The Commission has issued the enclosed Amendment No. 6 to Facility Operating License No. DPR-71 for Brunswick Steam Electric Plant Unit No. 1, and Amendment No. 28 to Facility Operating License No. DPR-62 for Brunswick Steam Electric Plant Unit No. 2. The amendments consist of changes to the Technical Specifications in response to your request dated March 21, 1977.

BRUNSWICK STEAM ELECTRIC PLANT, UNIT NO. 1

AMENDMENT TO FACILITY OPERATING LICENSE

SAFETY EVALUATION BY THE OFFICE OF NUCLEAR REACTOR REGULATION
SUPPORTING AMENDMENT NO. 6 TO FACILITY OPERATING LICENSE NO. DPR-71
AND AMENDMENT NO. 28 TO FACILITY OPERATING LICENSE NO. DPR-62
CAROLINA POWER AND LIGHT COMPANY
BRUNSWICK STEAM ELECTRIC PLANT, UNITS 1 & 2
DOCKETS NOS. 50-325 AND 50-324

Figure 6.2-1

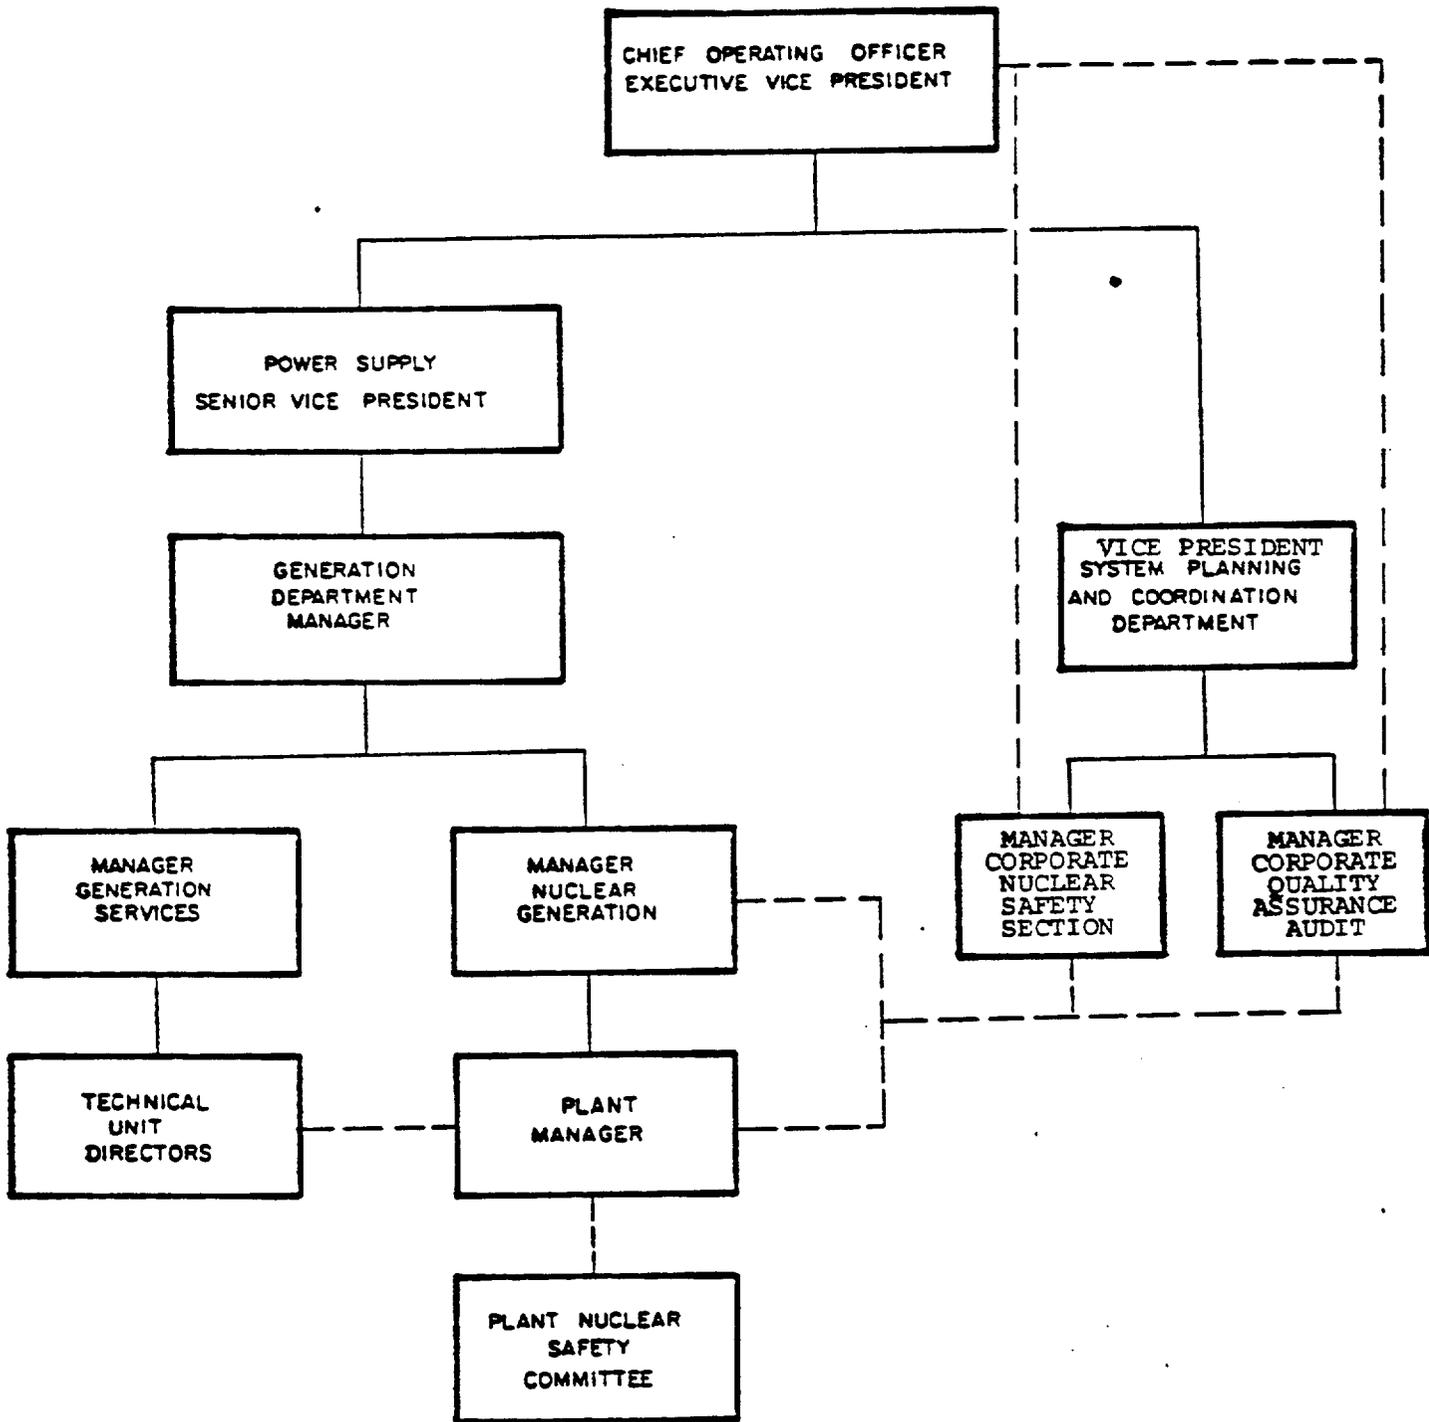
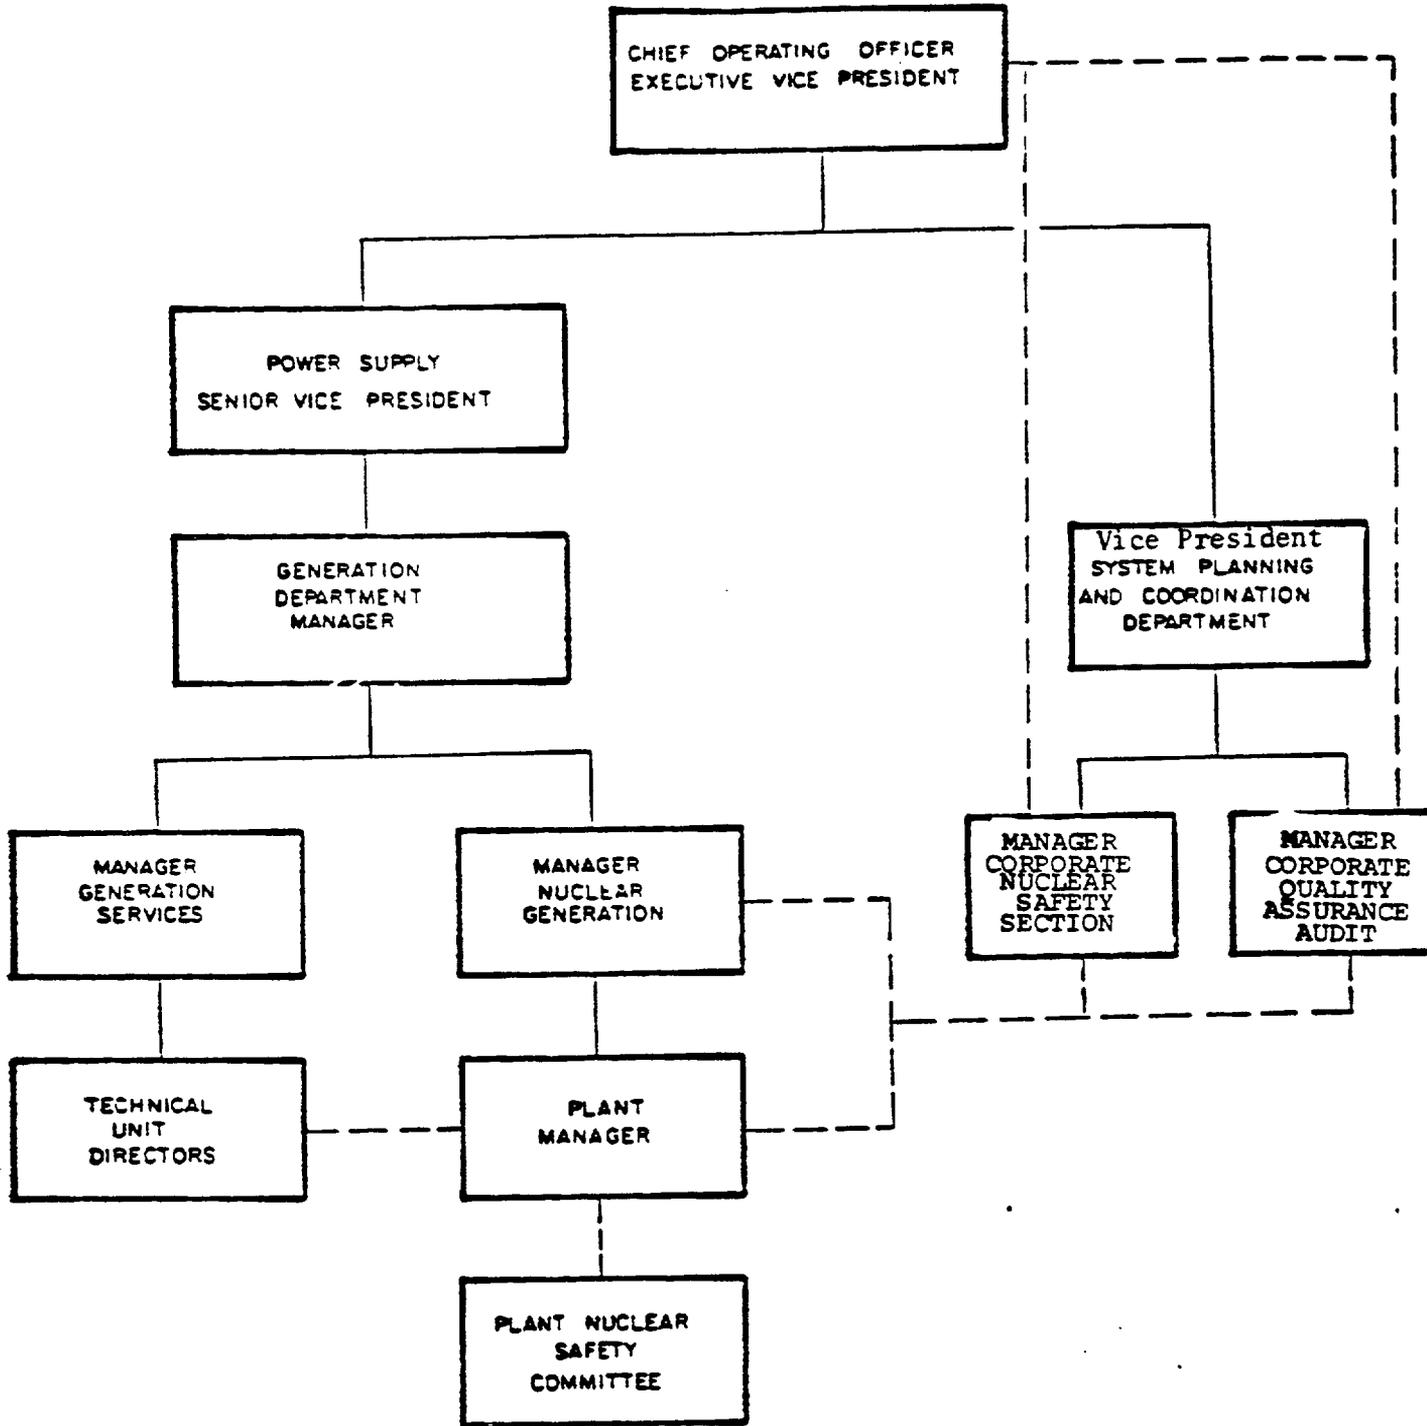
In the course of our review, we suggested the addition of position titles to some of the blocks shown on the new organization chart. This was suggested to clarify the relationship between the organization shown in the organization chart and the position titles used in the text of the technical specifications. We also suggested a minor revision in wording to clarify the meaning of "Operations Group," i.e. those organizations reporting to the Chief Operating Officer. The licensee has agreed with both of these modifications.

1. The reporting official for the Manager - Corporate Nuclear Safety Section (CNSS) and the Manager - Corporate Quality Assurance Audit Section has been changed from the Department Manager of the Technical Services Department to the Department Head - System Planning and Coordination Department.
2. Recommendations of the CNSS and audit results from the Corporate Quality Assurance Audit Section are now submitted to the Company Chief Executive Officer; Company Chief Operating Officer; Senior

Vice President - Power Supply; and the Department Head - System Planning and Coordination. Previously such recommendations and audit results were submitted to the Company President; Group Executive - Engineering, Construction and Operation Group; Department Head - Bulk Power Supply; and the Department Head - Technical Services Department.

3. The title of Vice President - Bulk Power Supply has been changed to Senior Vice President - Power Supply.
4. Supplementary personnel for audit teams will be taken, when needed, from the Operations Group, instead of the Engineering, Construction and Operation Group.
5. Reports of any safety limit violations are now the responsibility of the Generation Department, instead of the Bulk Power Supply Department.
6. The Radiation Control Unit is now assigned to the Generation Services Section instead of the Nuclear Generation Section.

Figure 5.1-1

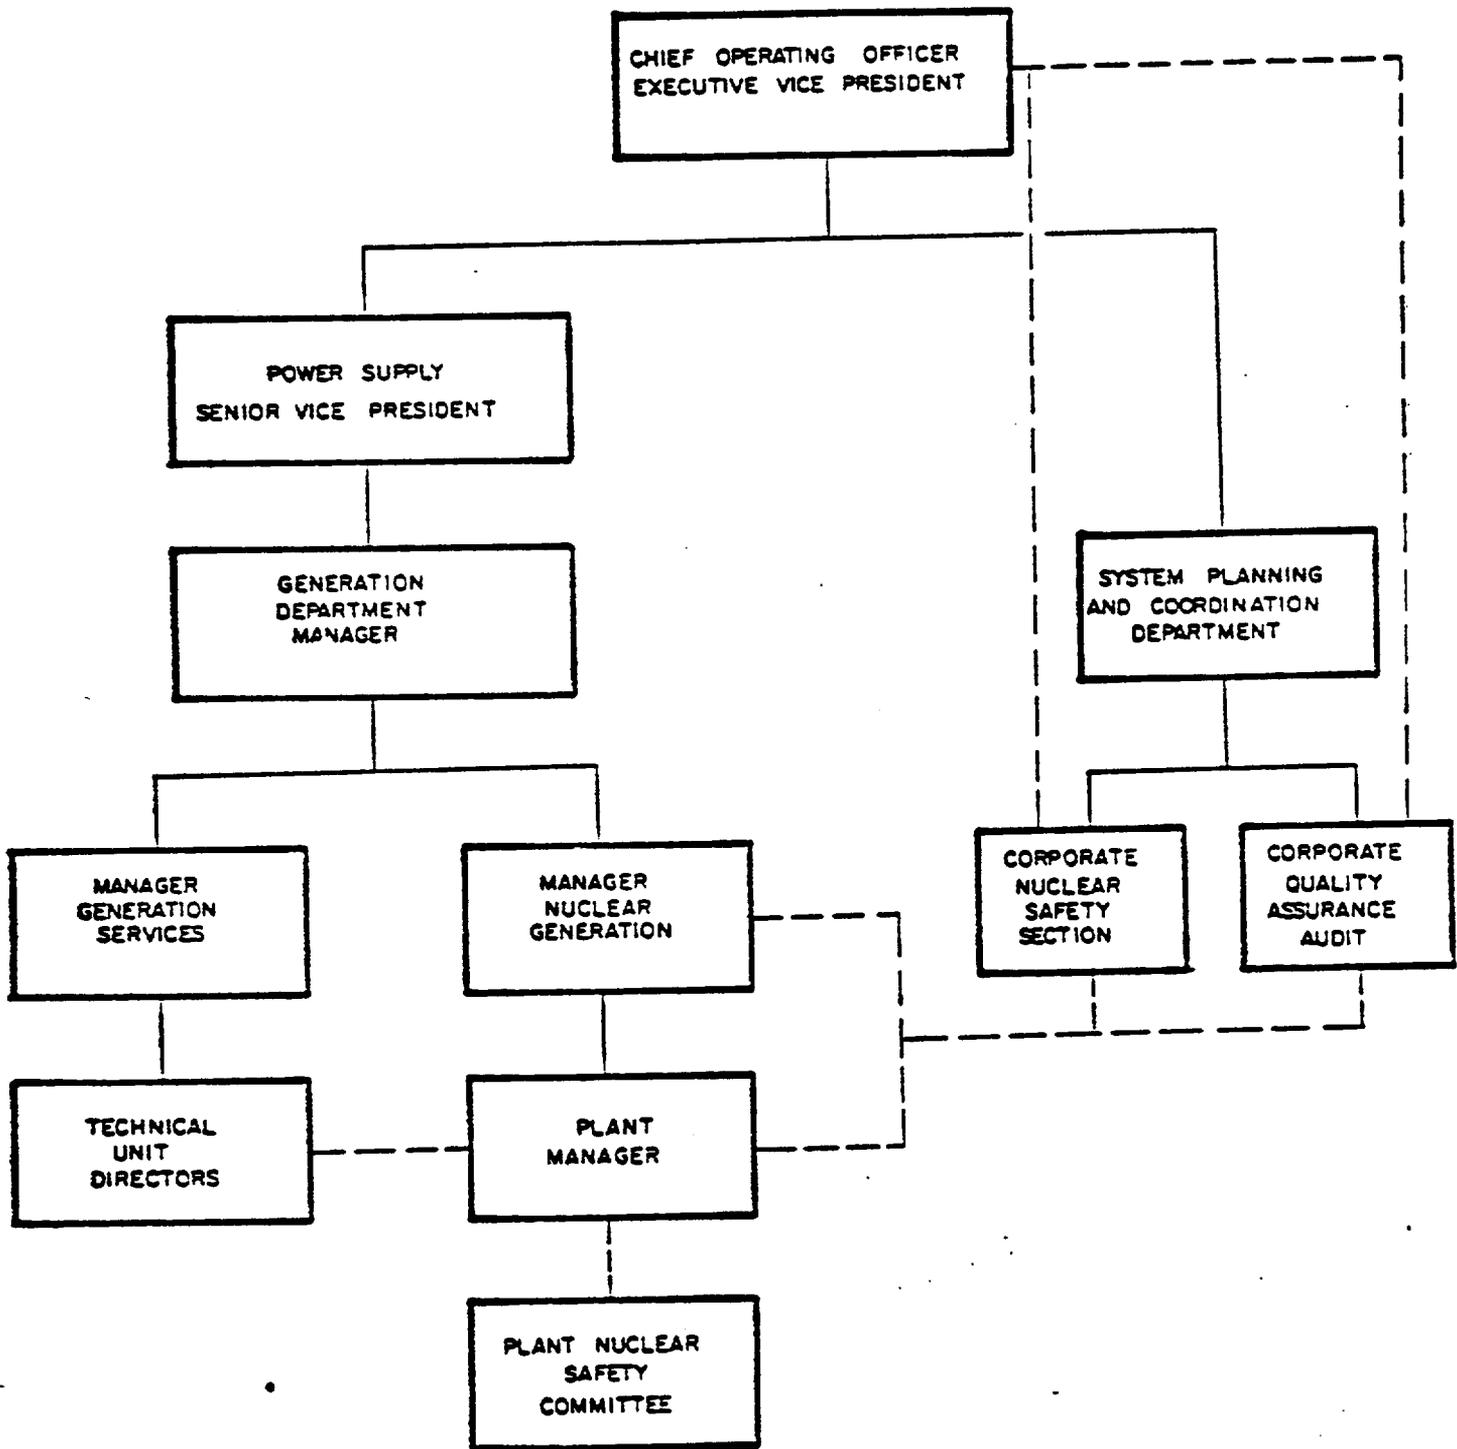
The Plant Manager is directly responsible for the safe operation of the facility as shown in Figure 5.1-1. In all matters pertaining to the operation of the plant and to the Environmental Technical Specifications, the Plant Manager is directly responsible to the Manager of Nuclear Generation. The Environmental and Radiation Control Supervisor is directly responsible to the Plant Manager for all Environmental Technical Specifications applicable to the plant, radiological and otherwise. The Radiation Control Unit of the Generation Services Section reports to the Manager - Generation Services and functions in a staff capacity to assist in the proper implementation of the Environmental Technical Specifications.

Figure 5.1-1

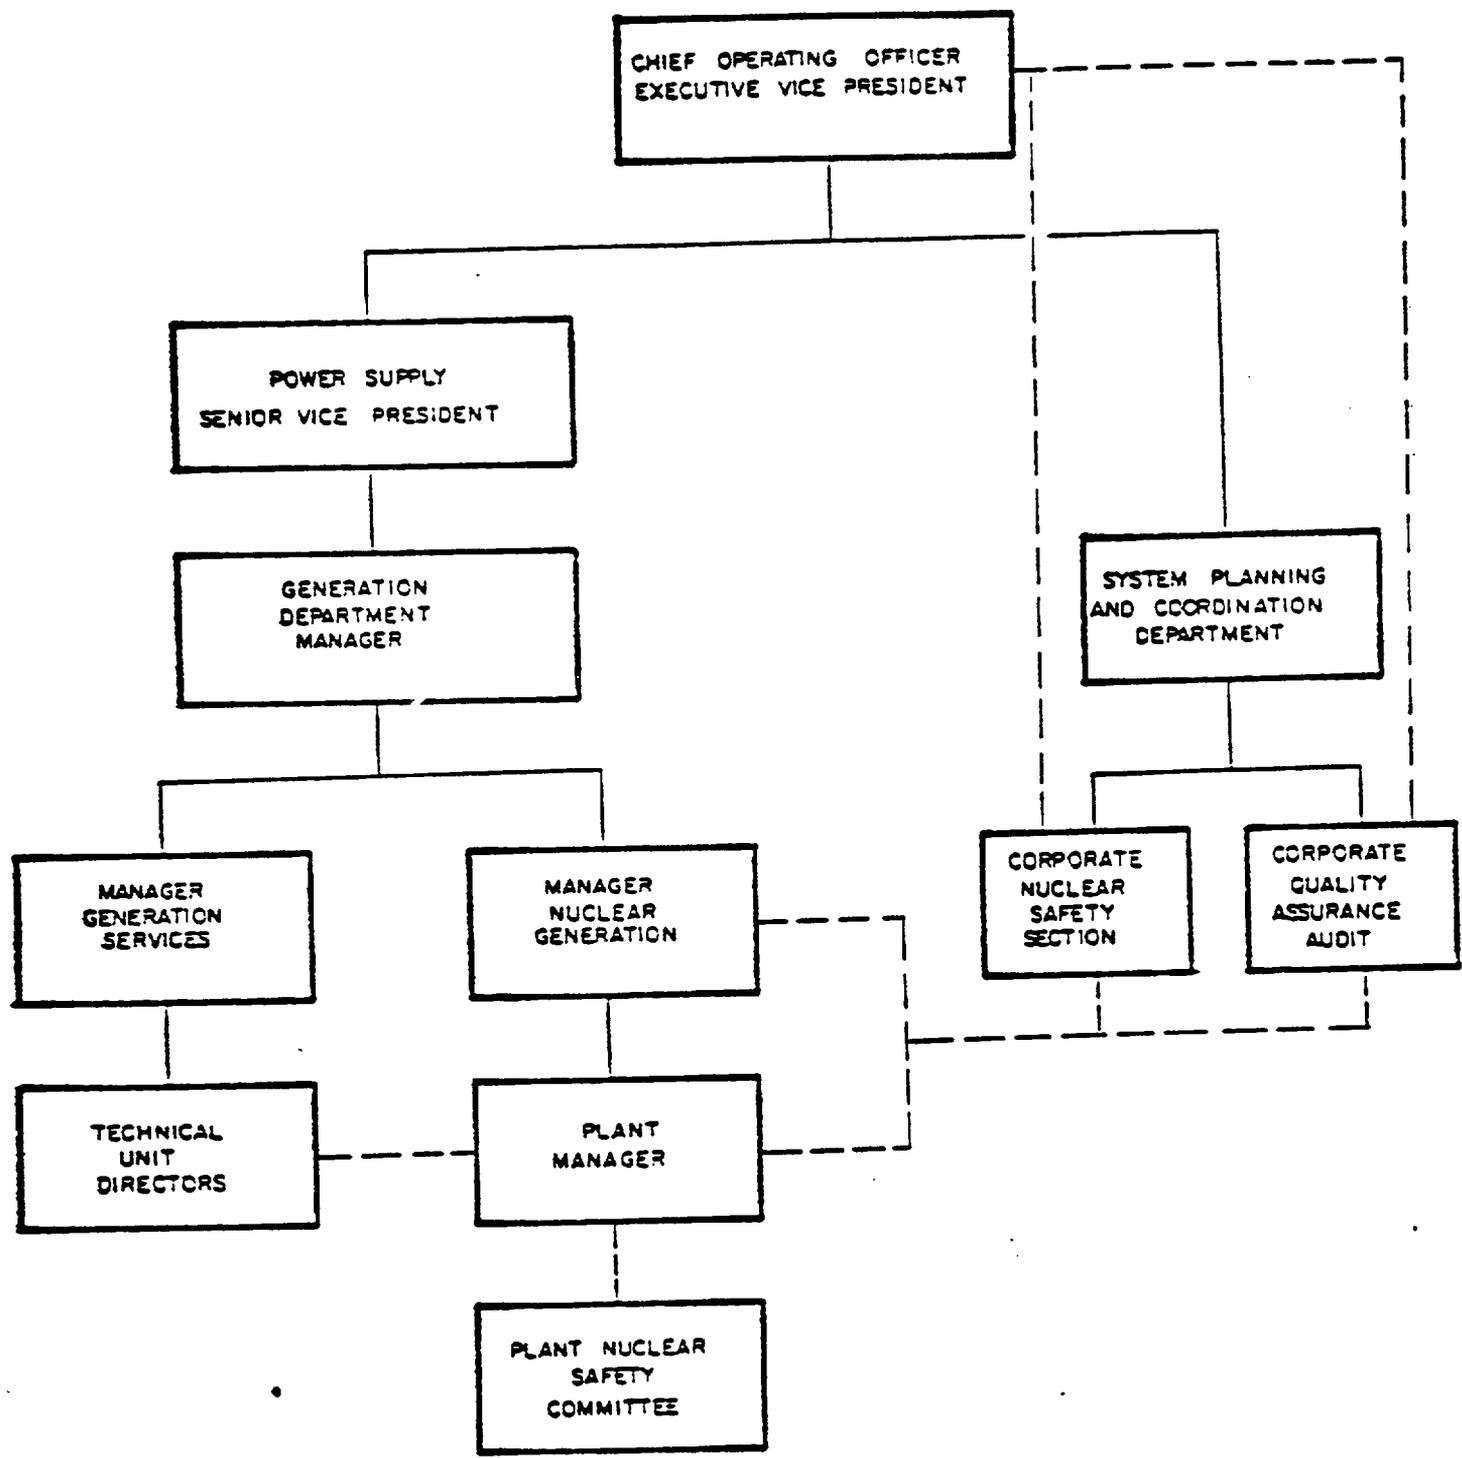
The Plant Manager is directly responsible for the safe operation of the facility as shown in Figure 5.1-1. In all matters pertaining to the operation of the plant and to the Environmental Technical Specifications, the Plant Manager is directly responsible to the Manager of Nuclear Generation. The Environmental and Radiation Control Supervisor is directly responsible to the Plant Manager for all Environmental Technical Specifications applicable to the plant, radiological and otherwise. The Radiation Control Unit of the Generation Services Section reports to the Manager - Generation Services and functions in a staff capacity to assist in the proper implementation of the Environmental Technical Specifications.
